Re: ***Addendum No. 2***
City of Canton Water Reclamation Facility
Phosphorus/Total Nitrogen Project Contract No. 26

Date: December 10, 2013

This Addendum forms a part of the contract documents and modifies the original bidding documents dated November 2013. Acknowledge receipt of this addendum in the space provided on the "bid form." Failure to do so may subject the bidder to disqualification.

CT JOB NO. 10182	CANTON WATER RECLAMATION FACILITY PHOSPHORUS/TOTAL NITROGEN PROJECT CONTRACT NO. 26 CITY OF CANTON, STARK COUNTY, OHIO	DATE	SCALE	ADDENDUM	SKETCH
CT Consultants engineers | architects | planners		12/10/13	1/4" - 1'-0"	# 2	S-1

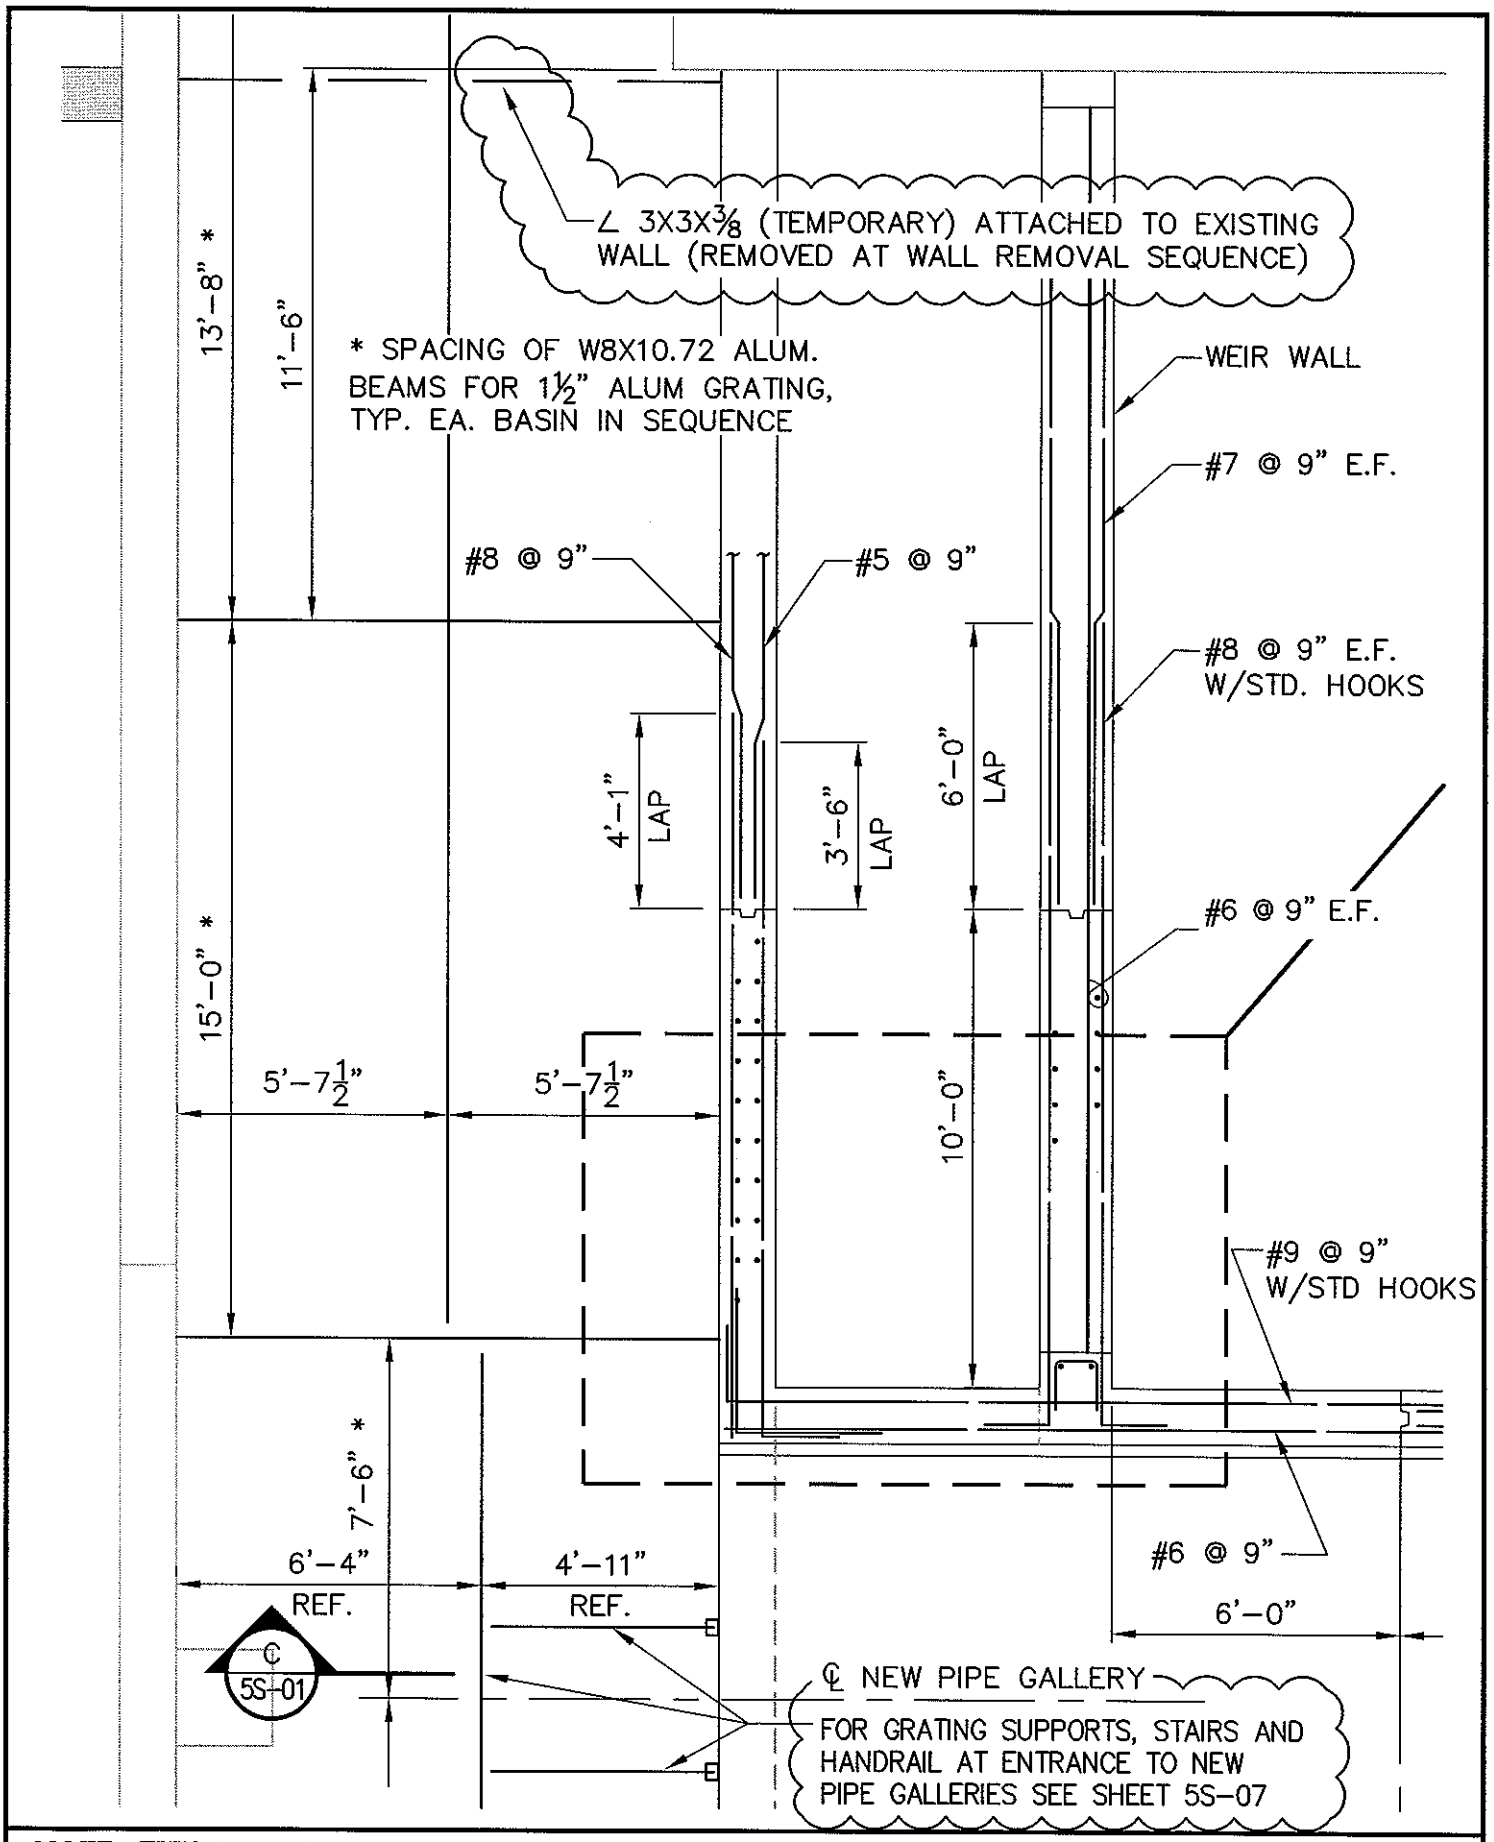
Sheet 122	5S-02	Sketch S-1	**ADD** notes
Sheet 127	5S-07	Sketch S-2	**ADD** detail for grating support
Sheet 127	5S-07	Sketch S-3	**REVISE** Section C_{5S-01}- C_{5S-07}
Sheet 136	5P-02	Sketch P-1	**ADD** Chemical Feed Lines and Notes
Sheet 140	5P-06	Sketch P-2	**ADD** Chemical Feed Lines and Notes
Sheet 144	5P-10	Sketch P-3	**ADD** Blind Flanges and REVISED Nitrogen Reduction Feed Line Notes
Sheet 242	12A-01	Sketch A-1	**REVISE** schedule

NOTE: THIS DRAWING SHALL BE CONSIDERED TO BE PART OF SHEET 122 OF 375 - 5S-02 .

CT JOB NO. 10182	CANTON WATER RECLAMATION FACILITY PHOSPHORUS/TOTAL NITROGEN PROJECT CONTRACT NO. 26 CITY OF CANTON, STARK COUNTY, OHIO	DATE	SCALE	ADDENDUM	SKETCH
CT Consultants engineers | architects | planners		12/10/13	3/16" - 1'-0'	# 2	P-2

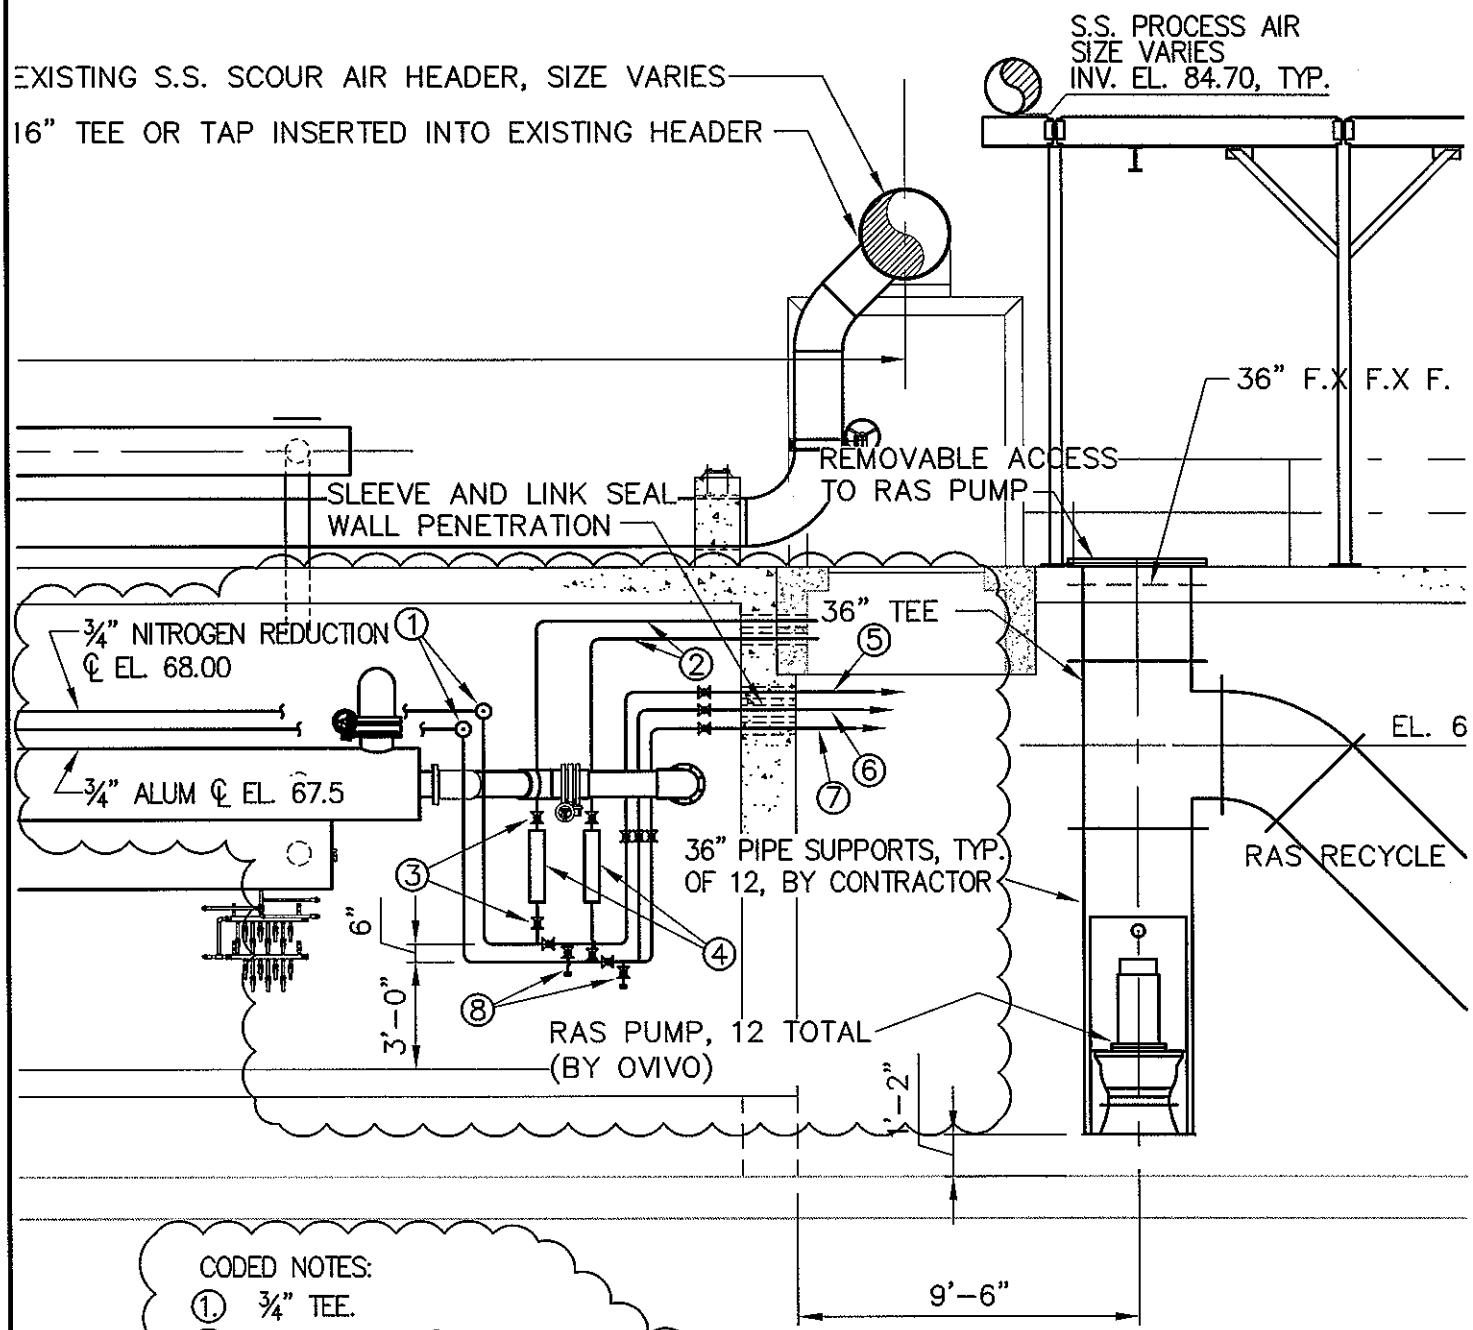
1. ¾" TEE.
2. VENT LINES –℄ EL. 70.50.
3. ¾" PVC BALL VALVES (TYP.).
4. 1000 ML CALIBRATION COLUMN (FLUID LEVEL MARKINGS IN GPH).
5. NITROGEN REDUCTION FEED LINE TO RAS RECYCLE WELL – ℄ EL. 67.50.
6. ALUM FEED LINE TO RAS RECYCLE WELL ℄ EL. 67.25.
7. ALUM FEED LINE TO PREAERATION ℄ EL. 67.00.
8. DRAIN CONNECTION WITH CAP.

1. ALL NITROGEN REDUCTION AND ALUM PIPING TO BE ¾" SCH 80 PVC.
2. PROVIDE LABELS OR PLACARDS FOR CALIBRATION COLUMNS, FEED AND VENT PIPING FOR NITROGEN REDUCTION AND ALUM.
3. INSTALL MIRROR IMAGE OF PIPING, CALIBRATION COLUMNS AND VALVES ON WEST WALL OF GALLERY. (TYP. FOR ALL TANKS)

NOTE: THIS DRAWING SHALL BE CONSIDERED TO BE PART OF SHEET 140 OF 375 - 5P-06.
